SUBJECT: Review of the Remedial Investigation Work Plan for the
Chippewa Valley Regional Airport Located at 3800 Starr Avenue
in Eau Claire

SUBJECT: Site Closure for Chippewa Valley Regional Airport Located at
3800 Starr Avenue in Eau Claire, WI

SUBJECT: Review of the Tank Closure Site Assessment Report for Two
Underground Storage Tanks Located at the Chippewa Valley
Regional Airport

PROPOSED SOIL BORING LOCATIONS MAP

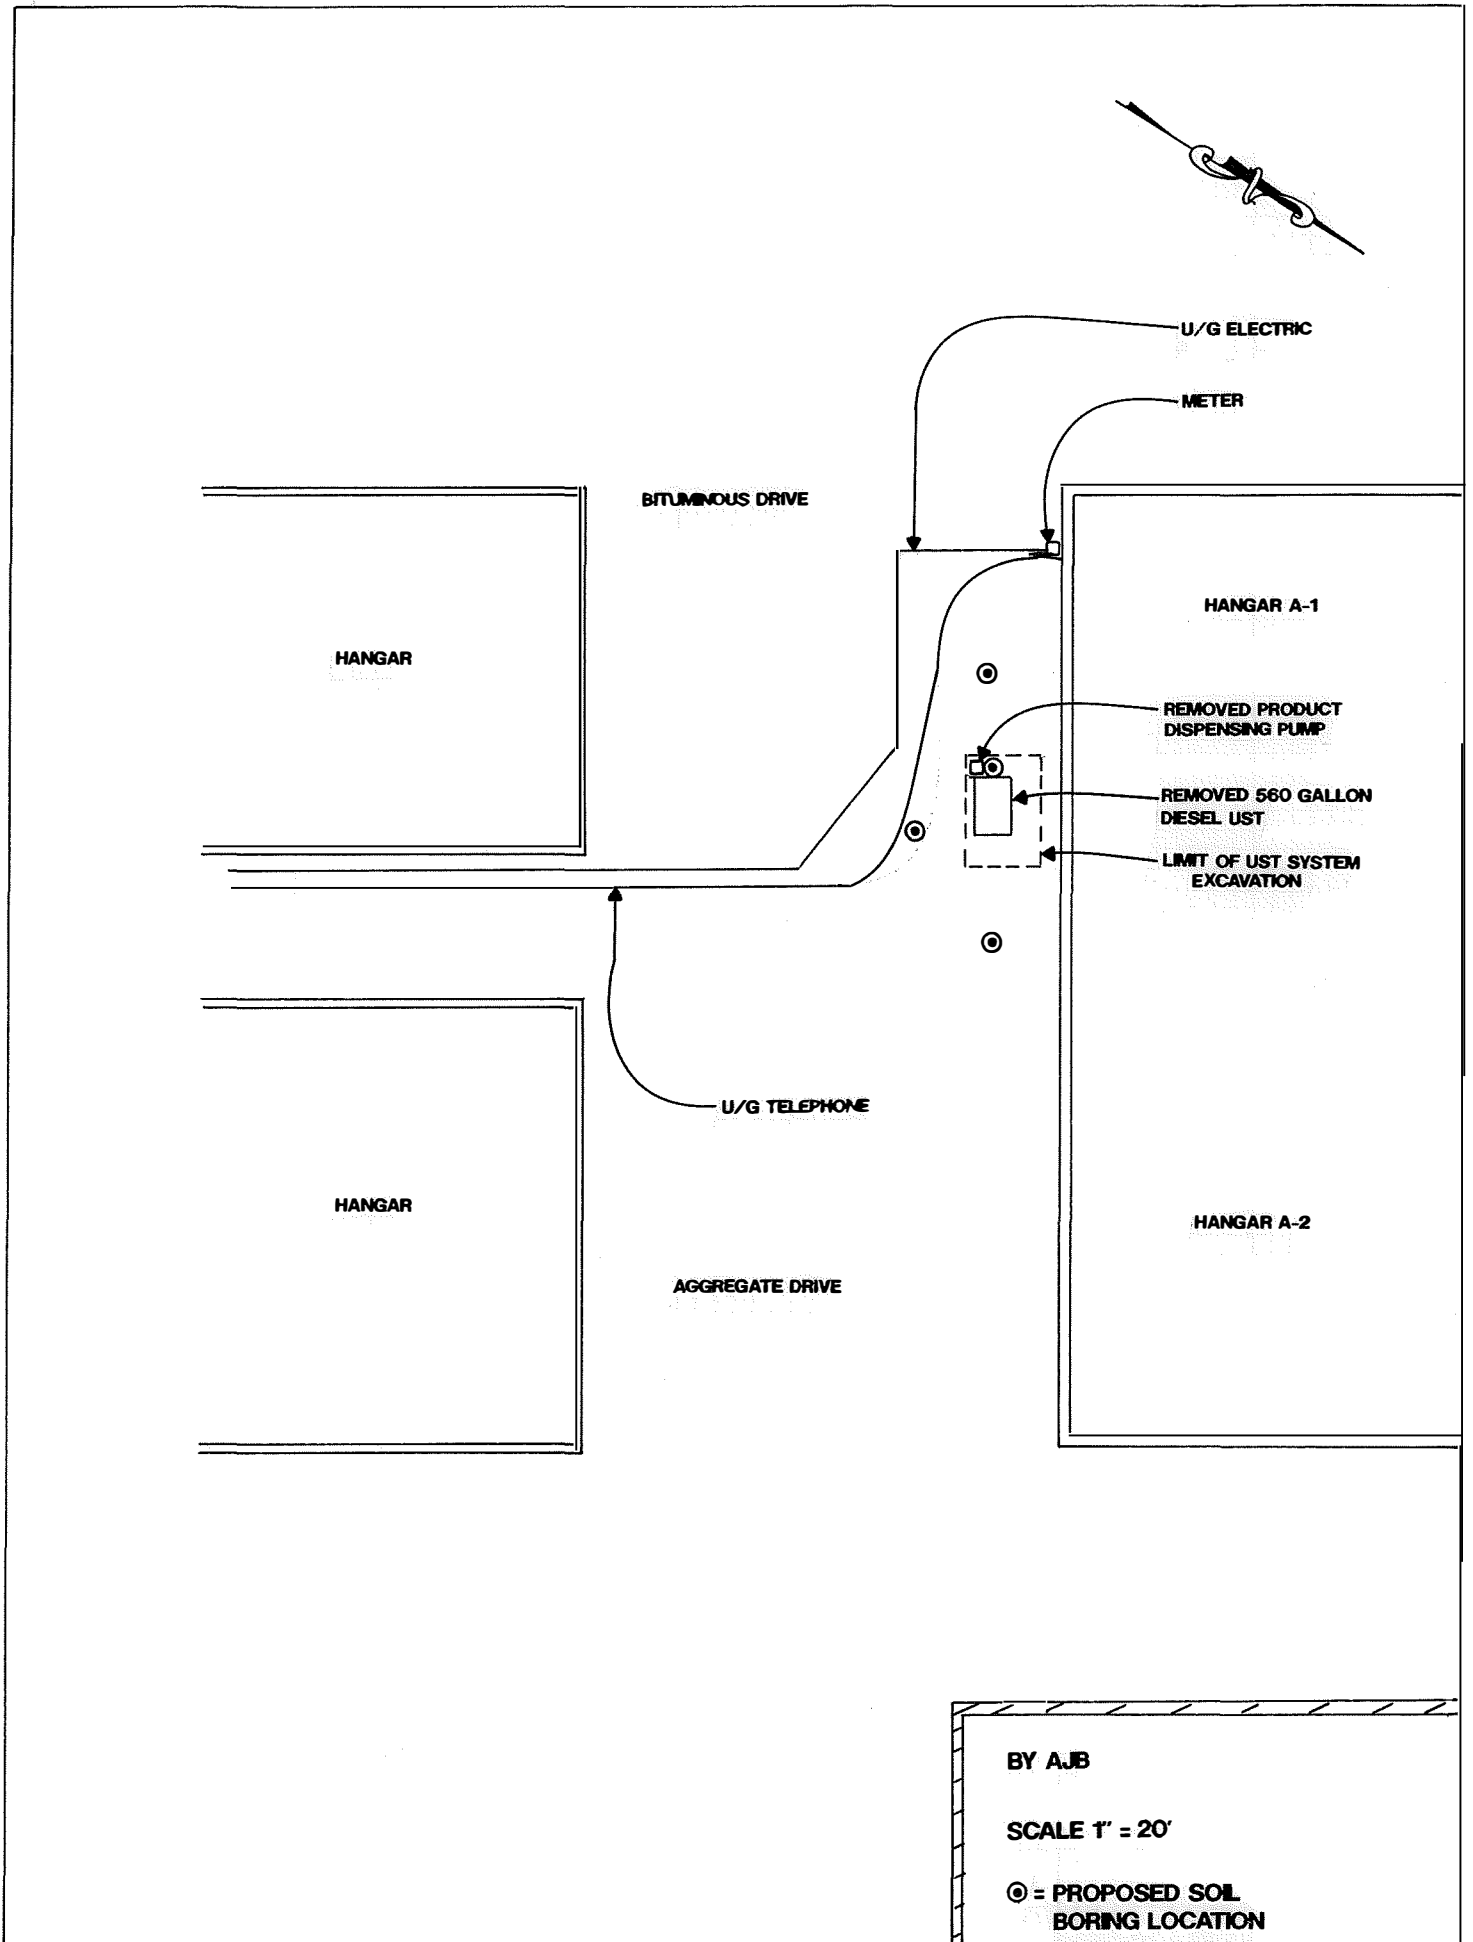
I have reviewed the above-captioned work plan that was submitted by Alan Bishop, Cedar Corporation. The work plan outlines the installation of four (4) soil borings to determine the degree and extent of contamination in the vicinity of a former diesel underground storage tank. This tank was located adjacent to Hangar A-1. The tank closure report indicated a release of petroleum contamination near the dispenser and below both ends of the tank.

The work plan states that field screening of soils from the borings will utilize a PID or FID. Since the tank contained diesel fuel, a FID must be used to field screen soil samples. I am approving this work plan as amended. If you have any questions concerning this letter, please contact me at (715) 839-3775.

FIGURE
2

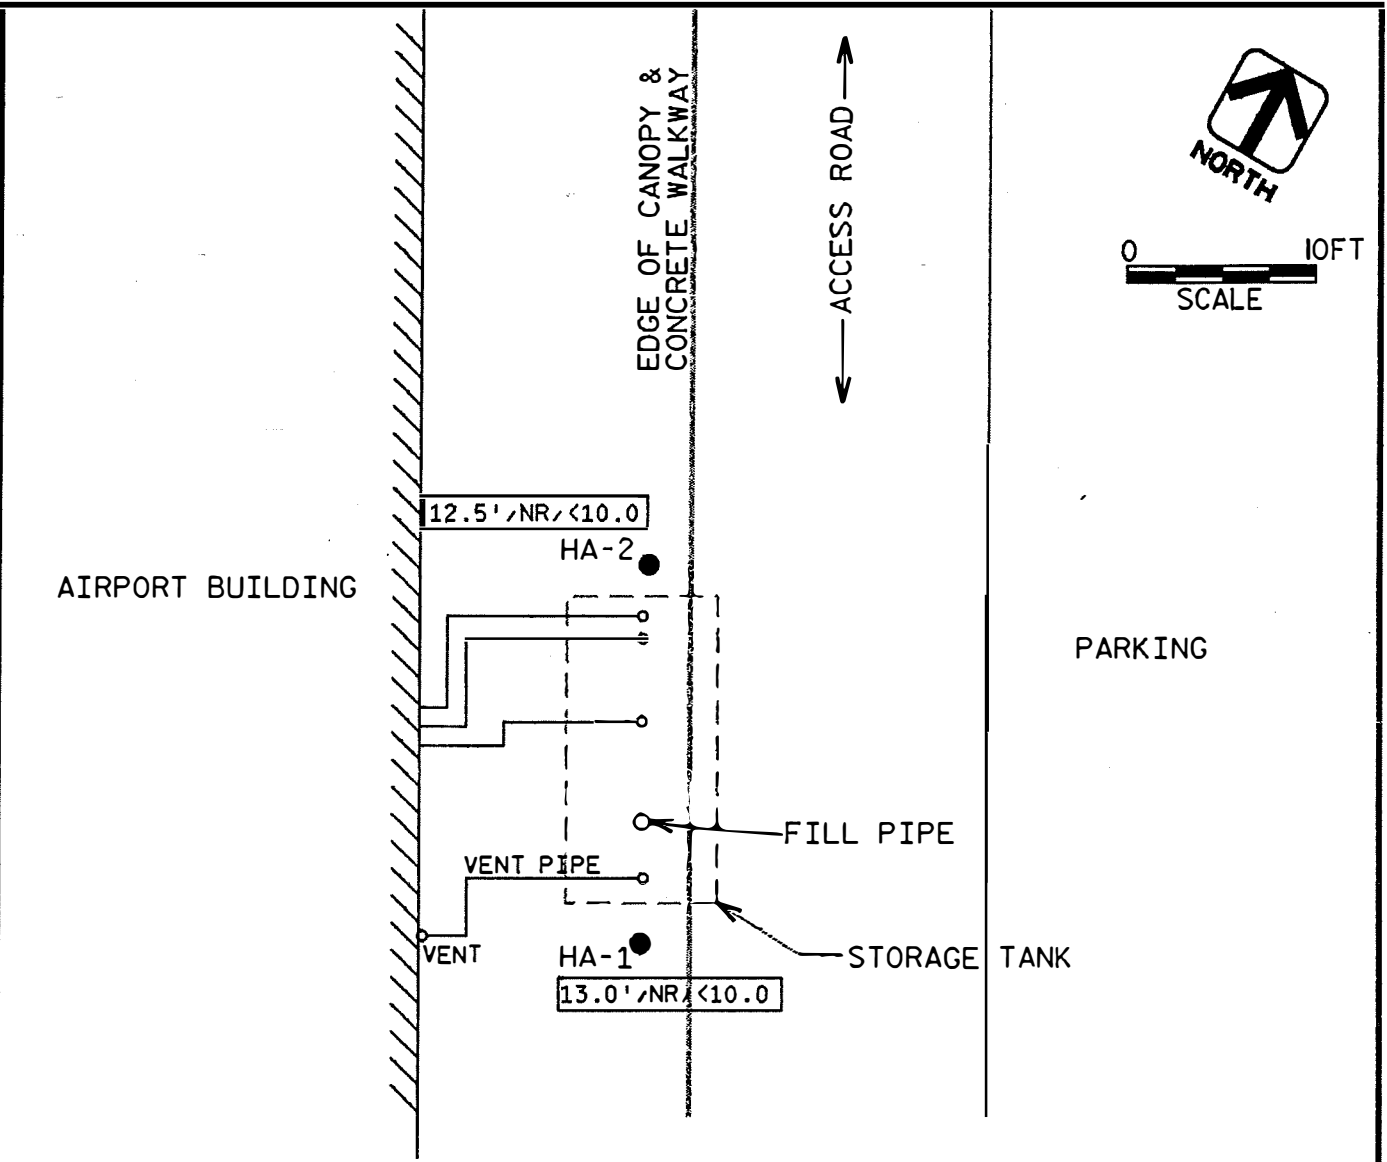
Enclosed please find one (1) copy of Figure 2, Site Plan for the Tank Closure Site Assessment for Chippewa Valley Regional Airport. After reviewing our field notes, we concur with Mr. Grump's observation that the walkway is 14 feet wide and we have amended Figure 2. Please consider this as an addendum to the January 1993 Tank Closure Report.
